3.0 Opportunities & Constraints

4.0 Design Development

<h1>Court Royal & Red Roofs Planning Commentary</h1>	
Number	Document	Comment	Rectification
1	Formal pre-application response	Significant concerns have been raised by the Council's Urban Design Officer, with regards to the building envelope's massing, bulk and depth.	The overall bulk, scale and mass has been altered significantly. The new proposal reduces the amount of potential overlooking and overbearing to the neighbouring properties. The height and scale of the front elevation is similar to previous application which was considered largely agreeable.
2	Formal pre-application response	The proposal creates an inappropriate relationship with neighbouring properties, noting its siting projects beyond the established front building line on this side of Church Road...	The building line has been pushed back to be in line with the neighbouring properties.
		...coupled with the very limited separation distances from the side boundaries.	The building has been made narrower to allow for more space between the side of the building and the boundary.

2020 Design Review Panel

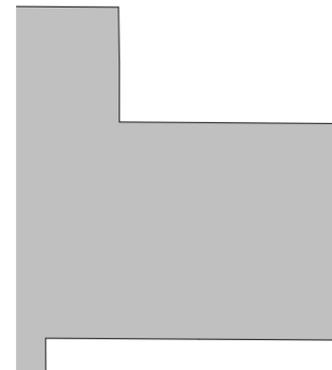
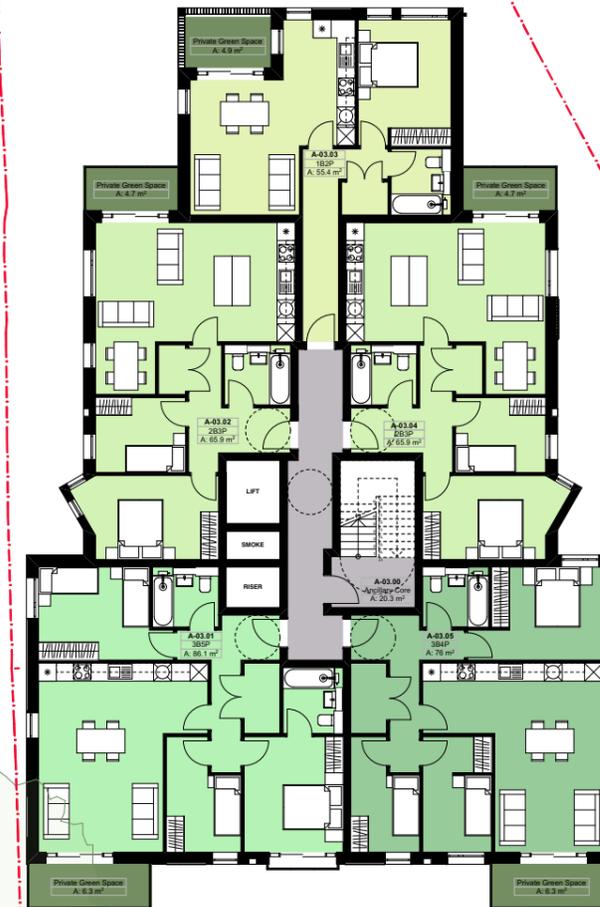
The proposal fills the site too much and in the wrong places. Whilst the principle of a 5-storey building here works, the quality of the open spaces is not good enough to make that height work successfully at present. Many of the proposal's problems stem from the decision to place the parking at the rear, and the consequent access requirements for this. This, coupled with the presence of mews houses at the rear, has knock-on negative consequences for the quality of the rest of the proposal. A large number of the issues that are detailed in this report, related to access, play, amenity and interior space, would all be easier to resolve if the parking was at the front and there was no mews housing.

4. The internal flat layouts should be improved with the number of single aspect units reduced and a better relationship between the internal layouts and the external space, particularly at the front of the building.

The updated typical floor plan vastly improves the overall floor plan and responds directly to comments made at the DRP.

Arguably the most obvious change is the removal of the studio unit on the south elevation. Studios in general are less desirable and are by definition are smaller than other dwelling types. Therefore, removing the studio and creating two larger 3-bed units which span across the south elevation introduce larger, higher quality dwellings with equally large private amenity space.

The two 2-bed units on the east and west flank walls are now dual aspect, with their living spaces containing multiple windows facing different directions. Their balconies are no longer awkward triangular shaped, but instead large rectangular shaped - allowing for better use of space. There is also still scope for screening if needed.

Some balconies are shown to be less than London standard, however for the final submission they will all be compliant with national standards.

The northern most dwelling is truly multi aspect and includes an inset balcony.
